# DANE COUNTY DEPARTMENT of PUBLIC WORKS, HIGHWAY and TRANSPORTATION

### RFB NO. 108059 - ADDENDUM NO. 1

#### LAKEVIEW BRICK TUCKPOINTING – PHASE II

EAST END ELEVATION E-E  
SCALE: NONE

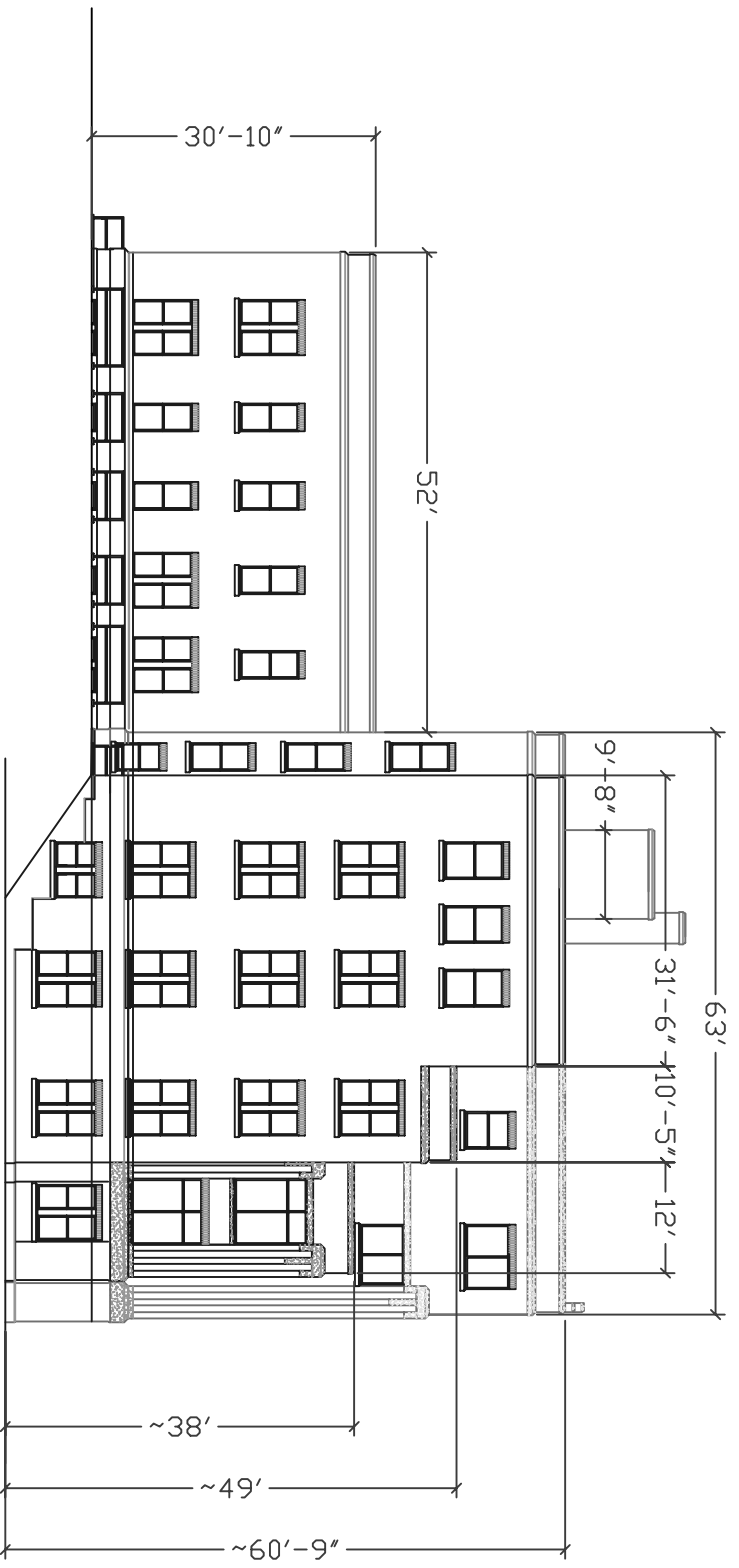
- xx. The original plans show two lintel stones to be replaced on the east face of the building. Instead, there is one stone at the southeast corner below the fourth floor windows that must be reset. The other stone is approximately 10 feet to the north of this stone and approximately 3 feet above the fourth floor windows. The face of this stone is cracking off at one end. Remove the small section that is cracked and reattach it to the stone with an exterior concrete adhesive approved by the Project Engineer.

NORTH ELEVATION D-D  
SCALE: NONE

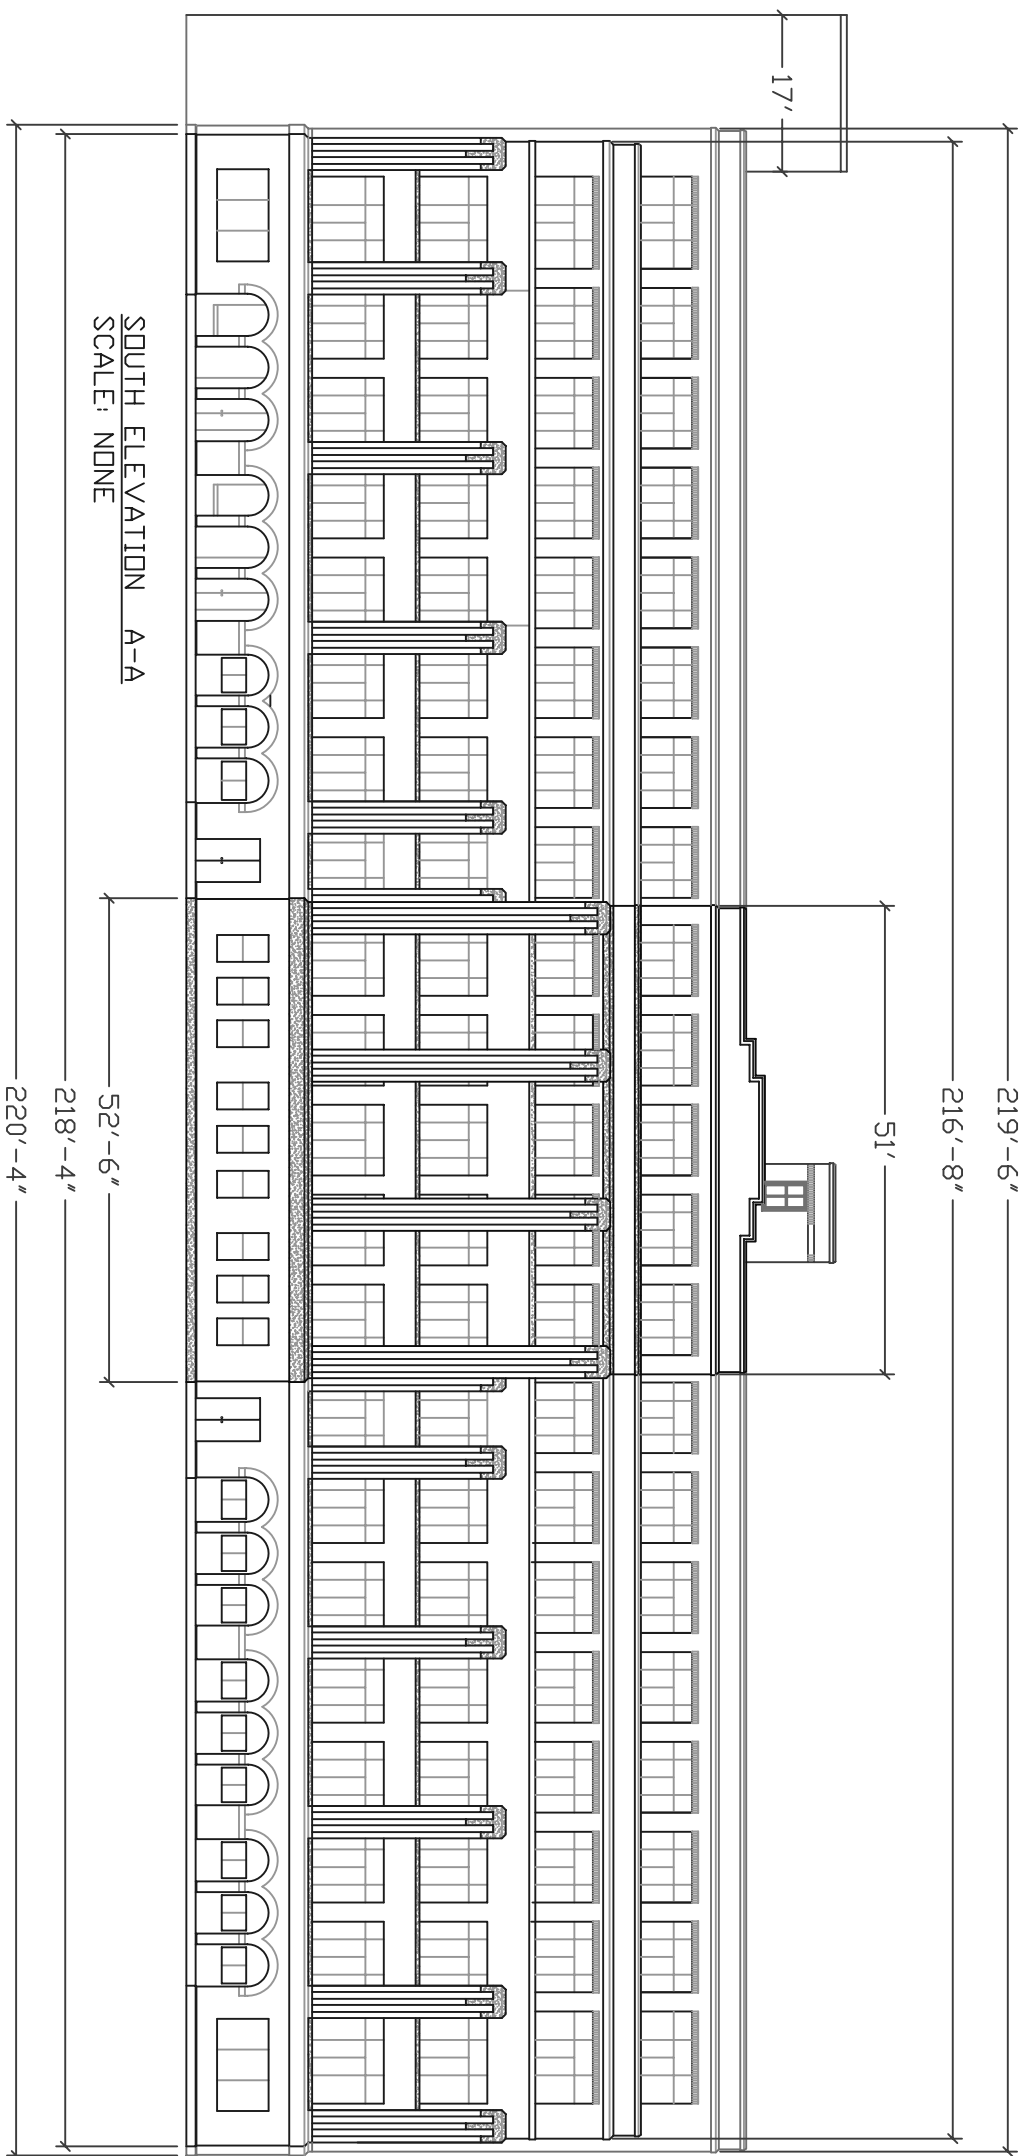
- xv. There are a total of 12 parapet cap stones that need to be replaced on the upper parapet wall on the north face of the building. Owner has marked the stones to be replaced. These stone range in length from 3-5 feet, and there is a total of approximately 50 feet of stone parapet caps to be replaced.
